Access Compliance Report

Public Rights-of-Way

Intersection ID: 3272	Main Street: HIGHCROFT_LN	Cross Street: WORSLEY_LN	Location:	N
ADA ID: 3EEB431110B9	Ramp Type: BlendTrans1	Initial Pass/Fail: Pass	Overall Compliance: No	Severity Score: 17.75
Codes/Mitigation Info/Possible Solution		Field Measurements/Component Compliance

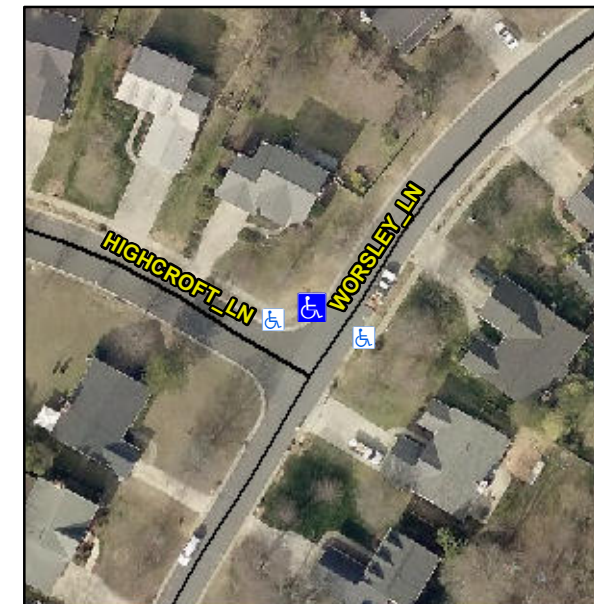
Not Found, R304.2.1, R304.5.3, R305, R302.7.2

Compliance	Description	Data	Compliance	Description	Data
N/A	Ramp Length (in)	52.0	Yes	BlendTrans Slope (%)	2.2
Yes	Ramp Width (in)	60.0	Yes	BlendTrans XSlope (%)	2.4
N/A	Flare Type LT	Sloped	N/A	Flare Type RT	Sloped
N/A	Flare Slope LT (%)	2.8	N/A	Flare Slope RT (%)	4.7
N/A	Flare Traversable LT?	No	N/A	Flare Traversable RT?	No
No	Landing Length (in)	43.0	No	DWS Provided?	No
Yes	Landing Width (in)	60.0	N/A	DWS Contrast?	No
Yes	Landing Slope (%)	0.7	N/A	DWS Length (in)	N/A
No	Landing X Slope (%)	3.2	N/A	DWS Full Width?	No
N/A	Landing Curb? (Y/N)	No	N/A	DWS Offset (in)	N/A
N/A	Shared Landing?	No			
Yes	Gutter Ponding?	No	Yes	Gutter Slope (%)	4.0
No	Gutter Lip Ht (in)	0.5	Yes	Gutter X Slope (%)	0.2
N/A	Painted X Walk1?	No	N/A	Painted X Walk2?	N/A
	X Walk 1 Direction	To S		X Walk 2 Direction	N/A
	X Walk 1 Width (in)	N/A		X Walk 2 Width (in)	N/A
	X Walk 1 Slope (%)	5.5		X Walk 2 Slope (%)	N/A
	X Walk 1 X Slope (%)	2.9		X Walk 2 X Slope (%)	N/A

N/A	Ramp inside XWalk1?	N/A	N/A	Ramp inside XWalk2?	N/A
	Road Slope (%)	2.9		Clear Space?	Yes
	Road X Slope (%)	5.5	N/A	Clear Space to XWalk (in)	N/A
Yes	Any Obstructions?	No	Yes	Storm Grate/Utility Hazard?	No
	Obstruction Type			Storm Grate/Utility Type	
			N/A		N/A
			Yes	Surface Condition? (G/P)	Good
			No	Curb Slope (%)	13.0

Remove & Replace Curb Ramp With Two New Directional Ramps or Equivalent.

Total Cost: \$ 3200.00
